**Sabine Pass to Galveston Bay, Texas  
Coastal Storm Risk Management and Ecosystem  
Restoration  
Final Integrated Feasibility Report and  
Environmental Impact Study**

**APPENDIX G**

**AGENCY AND TRIBAL COORDINATION**

**May 2017**

**p. 7-10, 7-11; 7.4.1 Orange-Jefferson CSR Plan:**

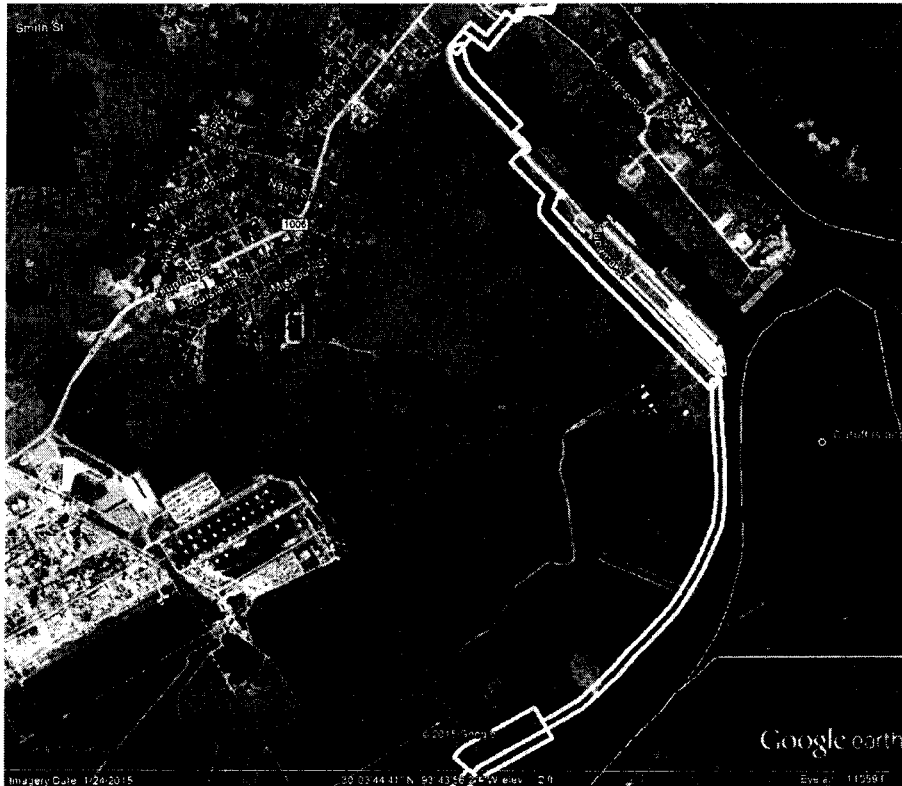
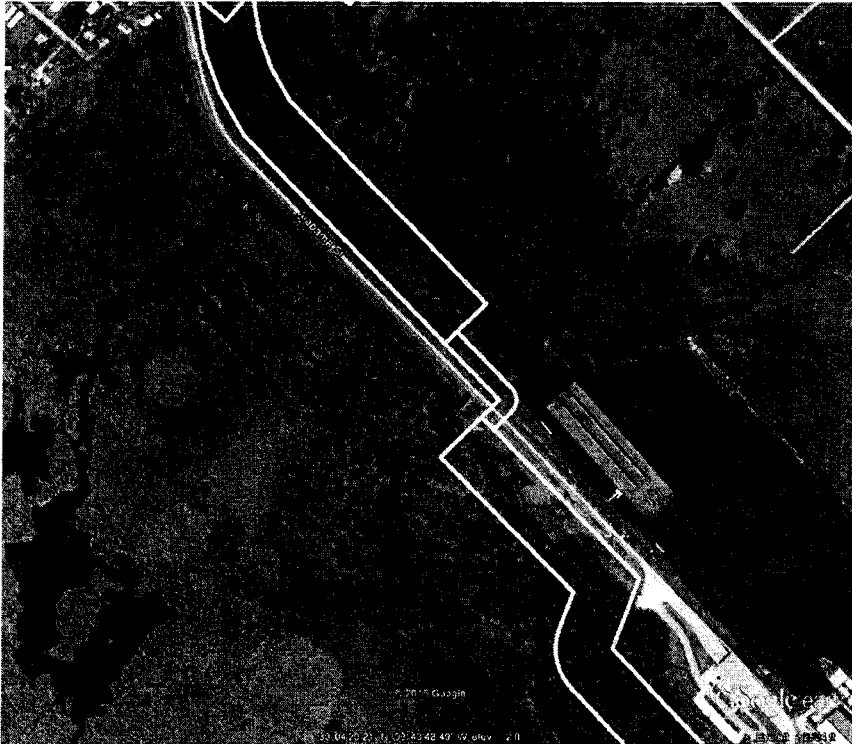
**Comment:** While in general, the preferred alternative avoids and minimizes impacts to wetlands, there is one location where additional avoidance and minimization appears to be possible and desirable (see map below). This marsh is currently largely impounded by the existing dredged material placement area, a levee, a road, and upland/development. However, there is at least one

significant connection to the adjacent water via a canal on the northeast side where the road crosses over a bridge. It is not clear, but it appears the plans do not include provisions for a gate at this location. This would have the effect of impounding the northeast half of this marsh, in combination with existing internal spoil banks. The half of the marsh to the southwest of the internal spoil banks would appear to remain open to the channelized lower reach of Adams Bayou, which is proposed to be gated. Since the gate is proposed to remain open most of the time, this section of the marsh should not actually be impounded by the proposed project. However, there low spoil banks along the marsh's shoreline on Adams Bayou, which may serve to partly impound this section of the marsh. In addition to the "external" impounding features, the entire marsh appears to be internally impounded by a low levee. There is also a rectangular, open water impoundment in the center, and a road and other features associated with historic oil and gas activity. While this marsh is clearly degraded, it still has significant ecological value, and could be enhanced/restored.
